**CONTRACT NO. 1773A**

**SHERADEN PARK ECOSYSTEM MAINTENANCE**

**ADDENDUM NO. 1**

**ATTACHMENT C REVISED APPENDIX A – SHERADEN PARK ECOSYSTEM  
MAINTENANCE PROJECT AND INVASIVE SPECIES BOUNDARY MAP**

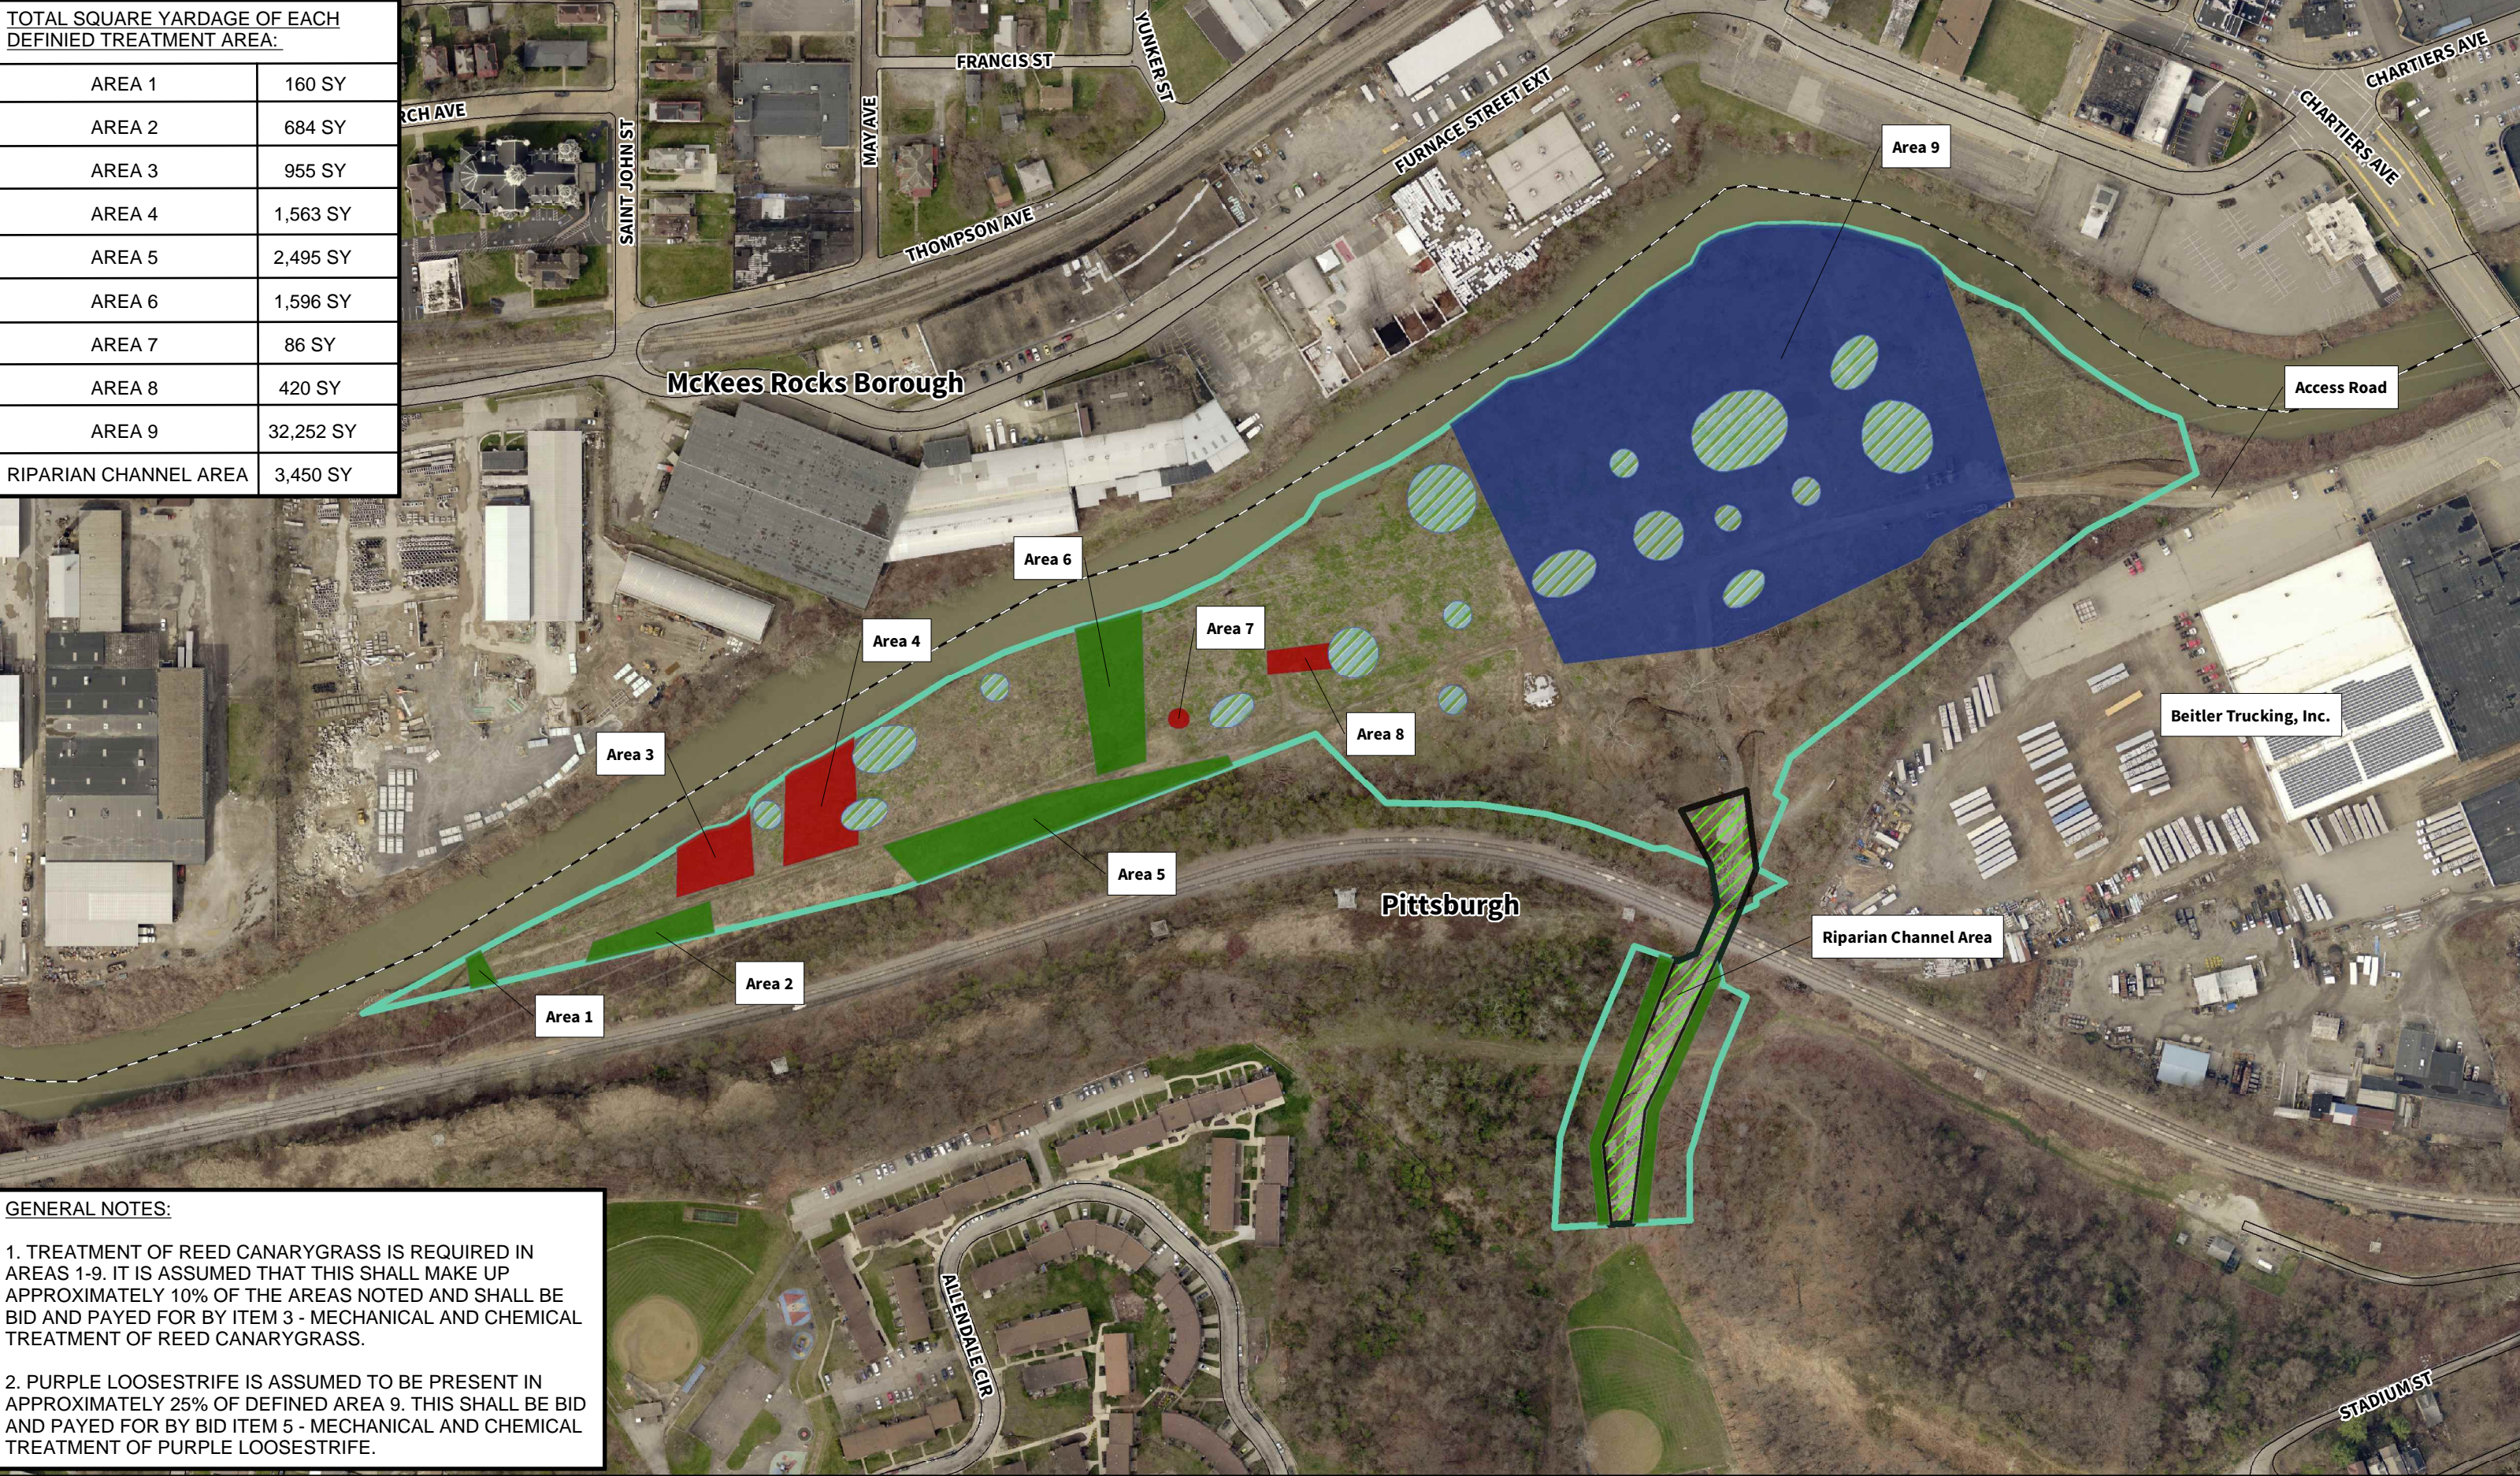
1. Update “Sheraden Park Ecosystem Maintenance Project and Invasive Species Boundary Map” to replace Total Estimated Area of Each Invasive Species Table with “Total Square Yardage of Each Defined Treatment Area” Table to read:

1. Question: *How will the treatment areas be verified since the delineation bid item that was in Contract 1773 has been removed in Contract 1773A? Will the site be marked to indicate the exact areas as noted on the map prior to the start of work for this contract?*

2. Question: *Are contractors to assume the square yardage quantities on the map are what's under contract, or is treatment of all invasive species throughout the project areas expected?*

5. Question: *Is the entire stream channel section to be treated? Are the hillsides and rail beds to be treated?*

*Answer: The Owner will provide data for marking the areas defined in the map in Appendix A. Marking of these areas shall be performed by the Contractor and shall be incidental to the Lump Sum items for treatment of the invasive species in these areas.*

*Answer: Control of identified species is required for total extents of defined Areas 1-9. There may be an opportunity for undergoing a change order process if altering the expected treatment area is desired.*

*Answer: The entire stream channel is part of the defined treatment area for the contract. Areas outside of the property boundary and/or the areas defined on the map in Appendix A are not required to be treated in this contract.*
